※ 수정사항

- Ver1.0 [2017.03.16]

▷ DIGCOM XA(Xilinx-Artix) Board V1.0

Title	▷ DIGCOM XA(Xilinx-Artix) Board V1.0	
Size A3	Document Number: Push Key and LED, 7-Segment Interface	Rev 1.0
Date: Monday, March 20, 2017	Sheet 1 of 5

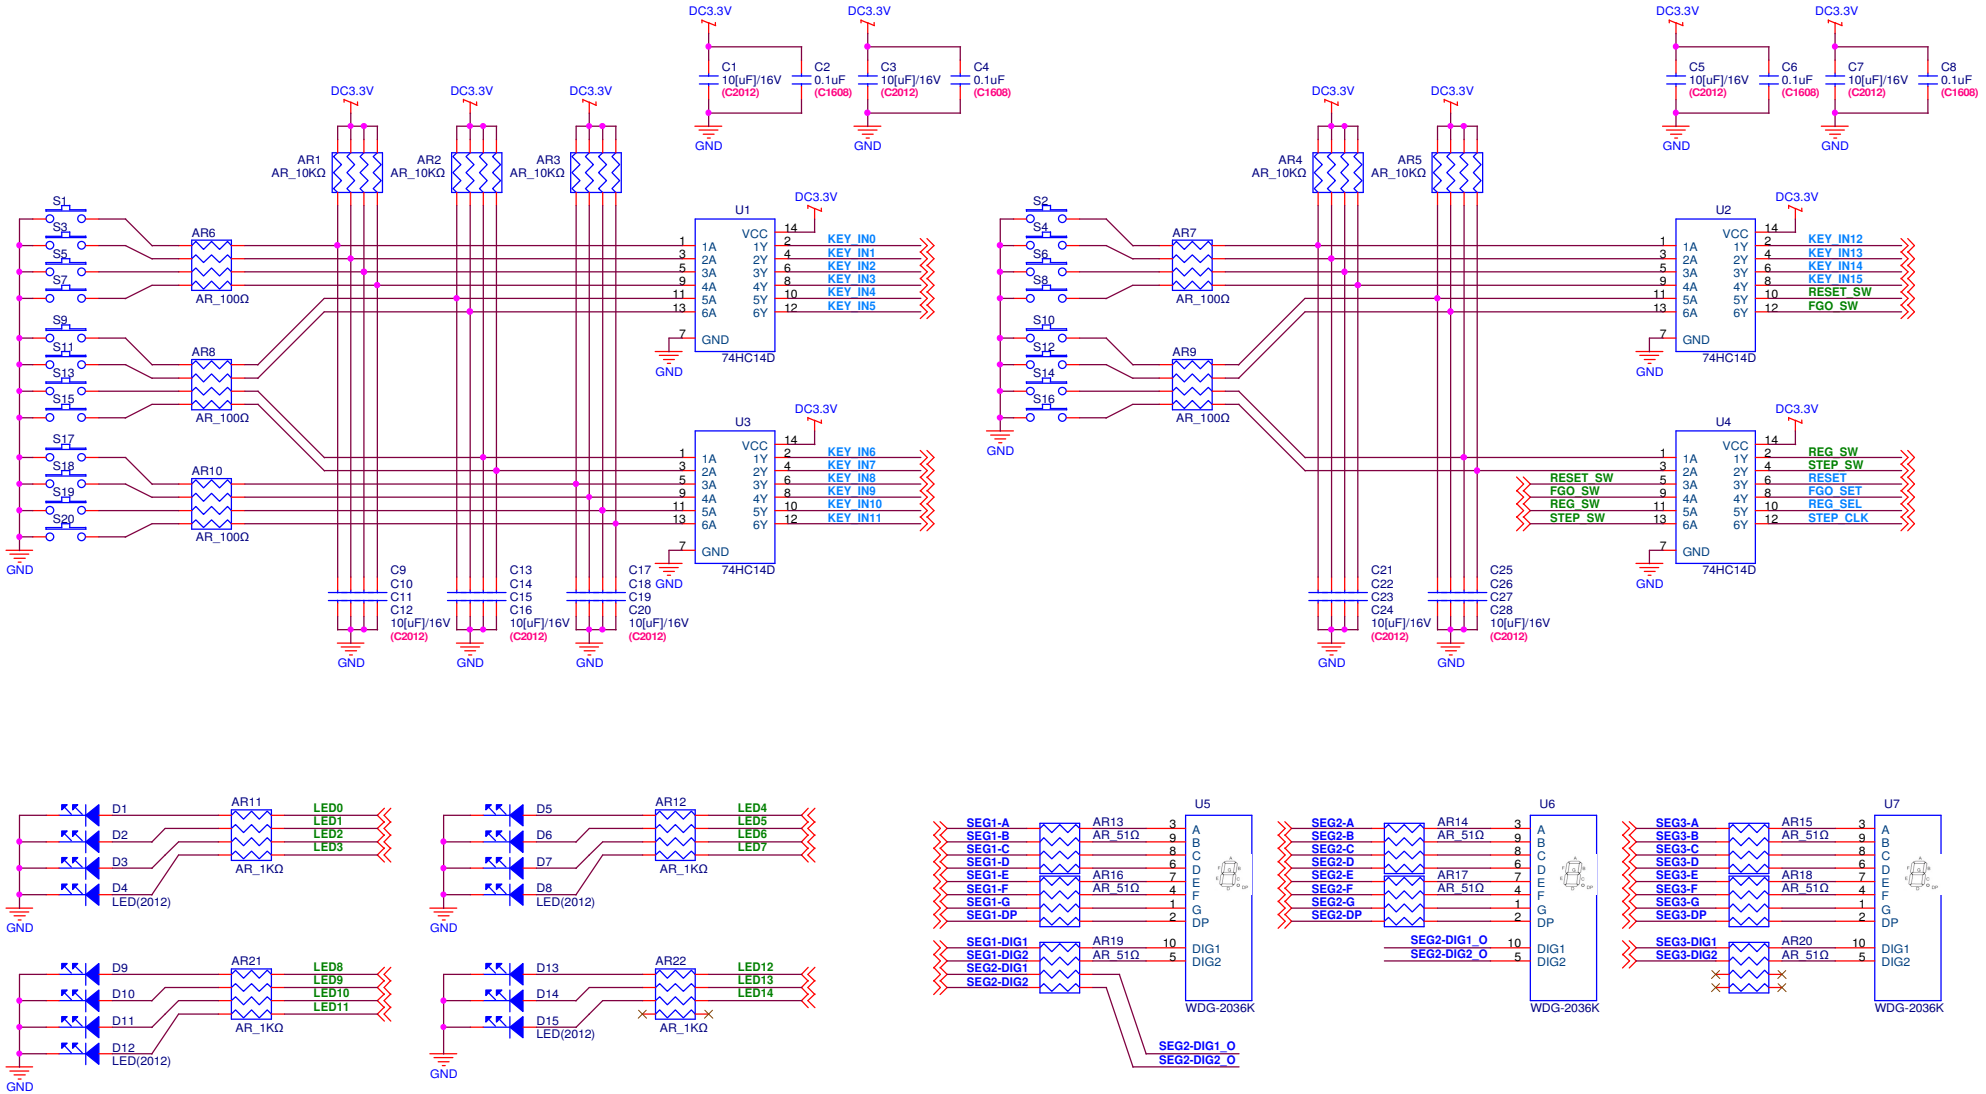
1. 보드명 수정 : DIGCOM-X2.0 -> DIGCOM-XA1.0
2. J2커넥터 외곽으로 1mm 이동배치
3. LED Silk 순서대로 정렬(1페이지 참조)
4. U21,U22번 부품 Thermal Pad 부분에 Via 추가(열패스 고려)
5. 4page GNDADC 부분 0옴 추가
6. "USB+5V" Silk 부분 옆에 Font 크기대로 수정
7. C46과 R35 실크 변경
